Access Compliance Report

Public Rights-of-Way

(Curb Ramps)

Intersection ID: 14505	Main Street: REMOUNT_RD	Cross Street: REMUS_RD	Location: NE
ADA ID: DC5A12BDE818	Ramp Type: PerpDiag	Initial Pass/Fail: Fail	Overall Compliance: No
		Severity Score: 72.5

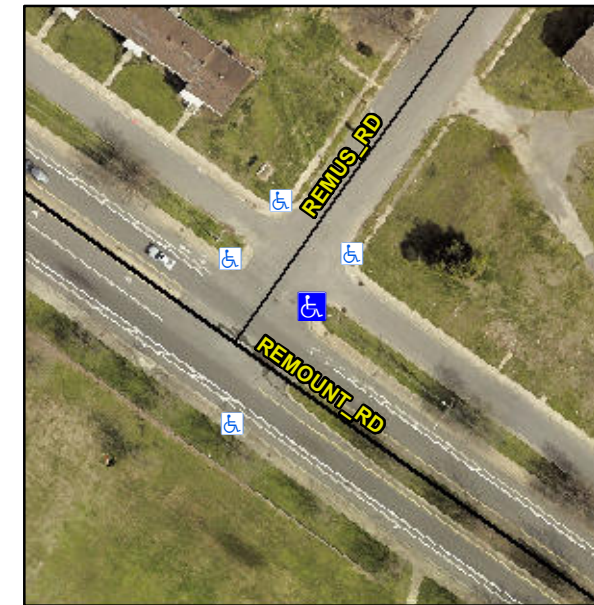
Not Found, R304.5.1, R304.2.2, R304.5.3

Compliance	Description	Data	Compliance	Description	Data
N/A	Ramp Length (in)	59.0	No	Ramp Slope (%)	10.6
No	Ramp Width (in)	25.0	No	Ramp XSlope (%)	9.1
N/A	Flare Type LT	N/A	N/A	Flare Type RT	N/A
N/A	Flare Slope LT (%)	N/A	N/A	Flare Slope RT (%)	N/A
N/A	Flare Traversable LT?	N/A	N/A	Flare Traversable RT?	N/A
N/A	Landing Length (in)	N/A	N/A	DWS Provided?	N/A
N/A	Landing Width (in)	N/A	N/A	DWS Contrast?	N/A
N/A	Landing Slope (%)	N/A	N/A	DWS Length (in)	N/A
N/A	Landing X Slope (%)	N/A	N/A	DWS Full Width?	N/A
N/A	Landing Curb? (Y/N)	N/A	N/A	DWS Offset (in)	N/A
N/A	Shared Landing?	N/A			
N/A	Gutter Ponding?	N/A	N/A	Gutter Slope (%)	N/A
N/A	Gutter Lip Ht (in)	N/A	N/A	Gutter X Slope (%)	N/A
N/A	Painted X Walk1?	No	N/A	Painted X Walk2?	No
	X Walk 1 Direction	To NE		X Walk 2 Direction	To NW
N/A	X Walk 1 Width (in)	N/A	N/A	X Walk 2 Width (in)	N/A
	X Walk 1 Slope (%)	6.7		X Walk 2 Slope (%)	4.9
	X Walk 1 X Slope (%)	4.5		X Walk 2 X Slope (%)	2.0

Remove & Replace Curb Ramp With Two New Directional Ramps or Equivalent.
